CONSULTATION REPORT

**National Capital Plan Draft Amendment 97 - Block 7 Section 4
Yarralumla (former Australian Forestry School)**

February 2024

Figure 116: Indicative site masterplan

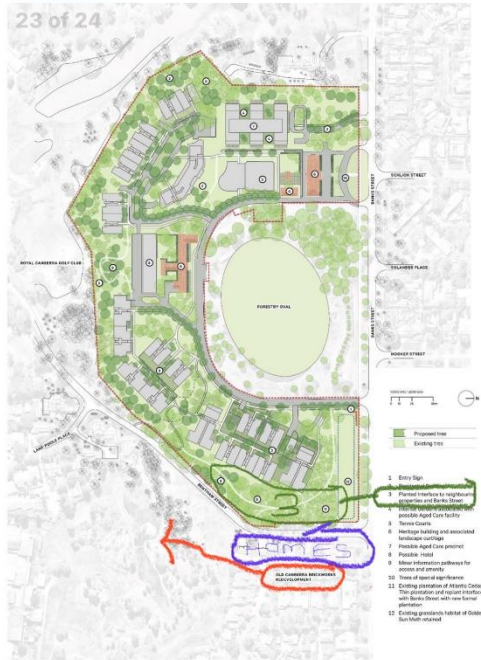
The "Indicative Site Masterplan" provides for a setback of 50m along Banks Street, however only a 20m set back along Bentham Street. As the new 3 storeys plus attic Dwellings will be in such close proximity to existing dwellings on Bentham Street the setback along Bentham Street should also be 50m, which aligns with the setback for most of the existing buildings on the Bentham Street side.

There are errors in the "Indicative Site Masterplan" Figure 116 and these should be addressed:

The North compass in Figure 116 is mis-labelled as it points East and there is no usable scale or dimensions.

The "Old Canberra Brickworks Redevelopment" is shown on the plan as extending to the corner of Bentham and Banks Street. This is incorrect the Canberra Brickworks development ends halfway between Lane Pool Place and the Bentham Street junction with Banks Street.

The Key in Figure 116 has errors and is unclear

- A path on the plan is labelled "9. Minor information pathways" – no information on what these are
- Page 18 states "Trees to be retained, and new plantings, should be generally as per Figure 116". This is a loose provision especially as the Figure 116 itself is indicative and hence not measurable or enforceable.

The legal status and standing of the "Indicative Site Masterplan" at Figure 116 is unclear and must be addressed.

Figure 115: Development controls for Block 7 Section 4 Yarralumla

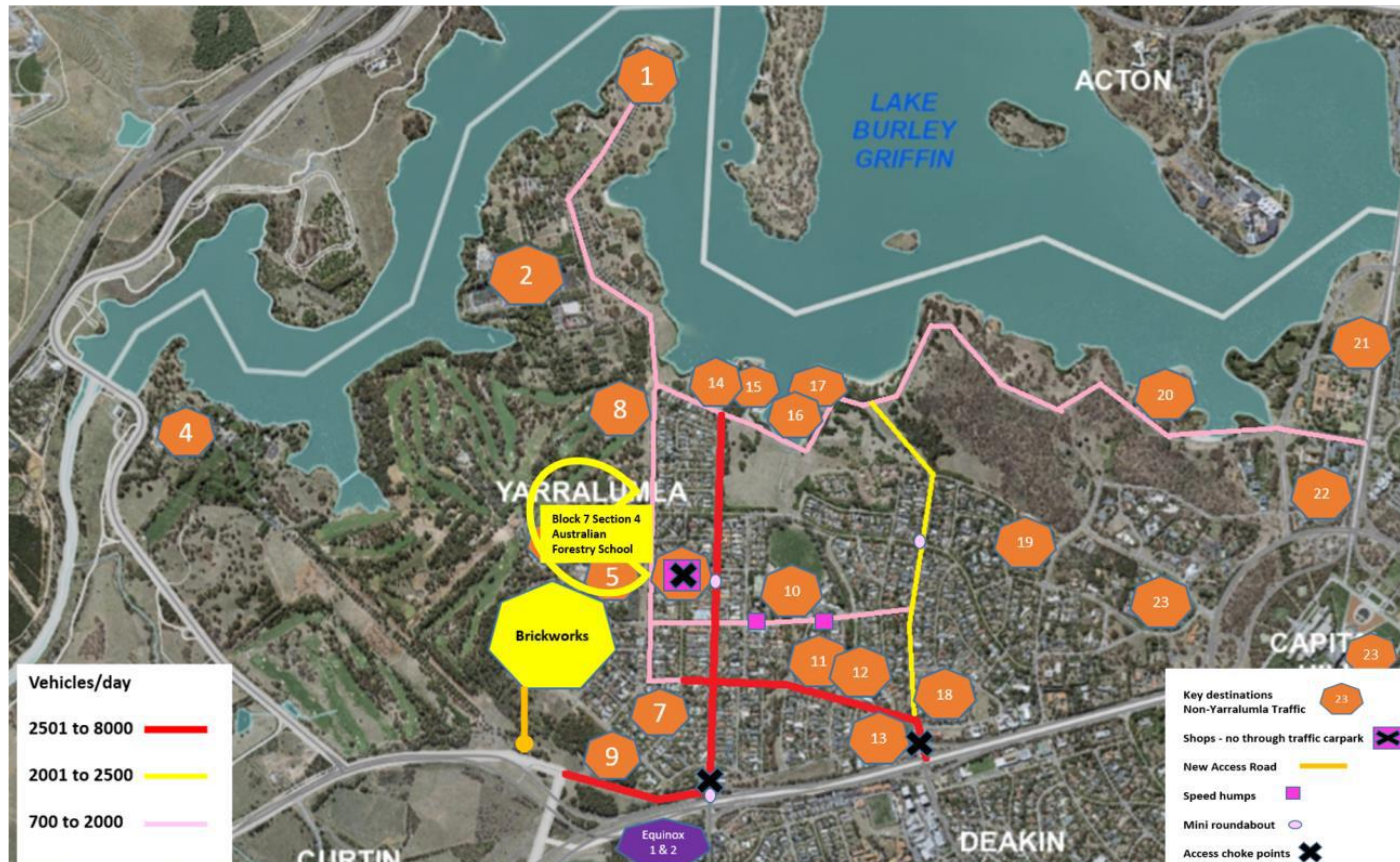
Figure 115 is problematic in setting out the development controls as it is a diagram with no scale, no dimensions, no labelling of existing buildings, no street names, no co-ordinates or other indications as to location, and boundary setbacks are not to scale.

Hence Figure 115 is in effect a sketch. Areas and elements are not defined, and as such it does not provide the development controls and would have no legal standing.

Page 17 refers to the "Development footprint". It states "To preserve the landscape qualities and character of the site, new buildings are limited to those areas identified in Figure 115, and in accordance as per the distribution of buildings shown in Figure

116.” and “The maximum developable area of the site, as shown on Figure 115, is 41,500m². However, Figure 115 does not define the areas for new buildings nor the developable area.

The Developable area 41,500 m2 is not defined in the Draft Amendment 97, as to what is included and excluded, nor does National Capital Plan include a definition. Clarity is required as to whether roads, courtyards, BBQ areas and paths, private gardens are included in the “Developable Area”.

Page 18 states “Within open space areas identified in Figure 115, minor structures and other elements such as paths, driveways, signage are permitted” however the open space is not defined because of the matters identified above.

Figure 115 should clearly define the Site and development controls and footprint to scale with dimensions, co-ordinates, streets and labelling of existing buildings, open space, developable area and other indications as to location in a manner suitable for a legal instrument.

The Developable area 41,500 m2 should be defined in the Draft Amendment 97.

Open Space should be defined in the Draft Amendment 97.

As a result of discussions with the YRA following the public consultation period, it was agreed that additional details in the drawings forming part of the draft amendment could help clarify and provide certainty to the community about setbacks and developable area of the site. The relevant drawing has been amended to reflect this.

Australian Forestry School abuts 4m wide Wilf Crane Crescent

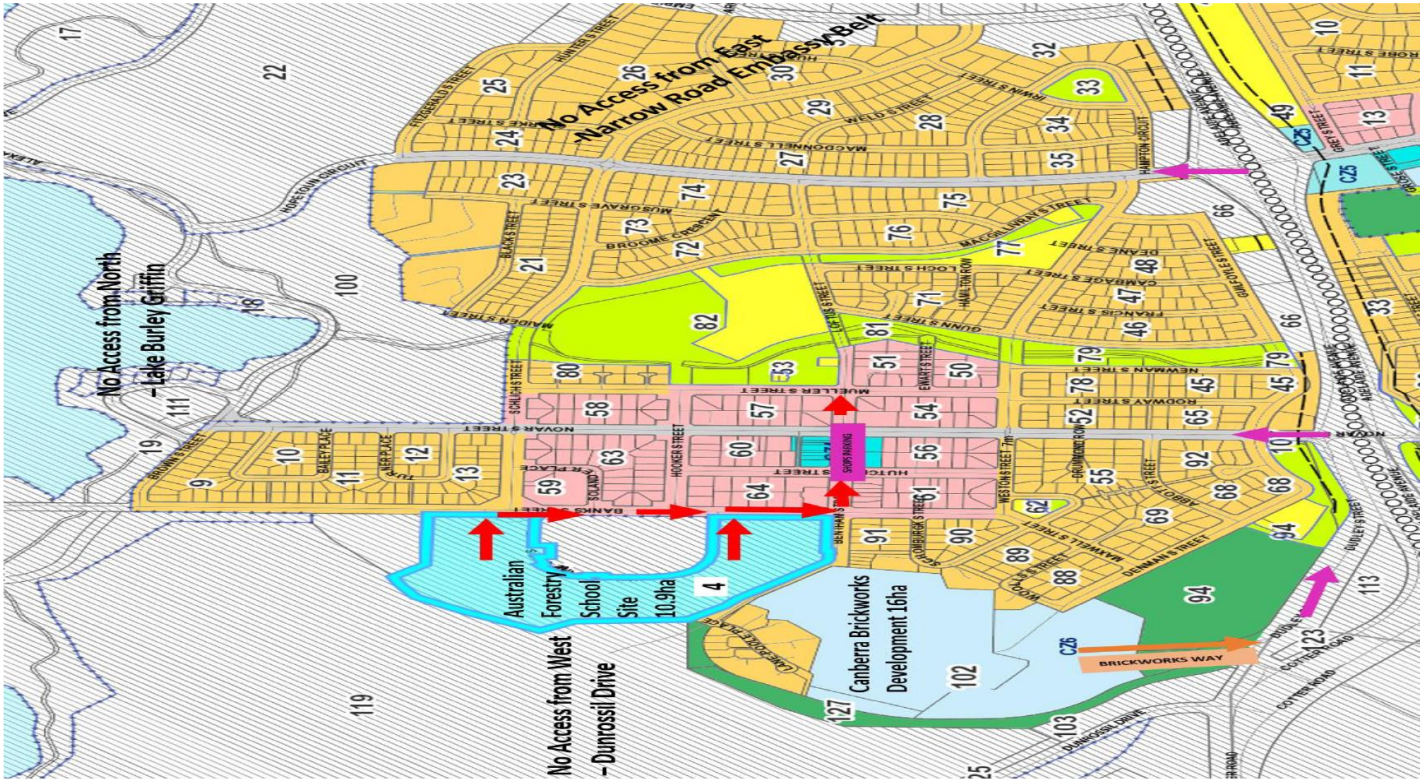
The Forestry School Heritage Building is at high risk of traffic damage to its walls and foundations post the development of the Site. Provisions for its protection are required in the Draft Amendment 97. The north segment of Wilf Crane Crescent is only 4m wide where it directly abuts the Forestry School Heritage Building and down to Banks Street. This section is one-way traffic and cannot be widened, the constraint being that the south edge of the road is at the boundary with the ACT Government’s Public Playing Field (Block 4 Section 4 Yarralumla).
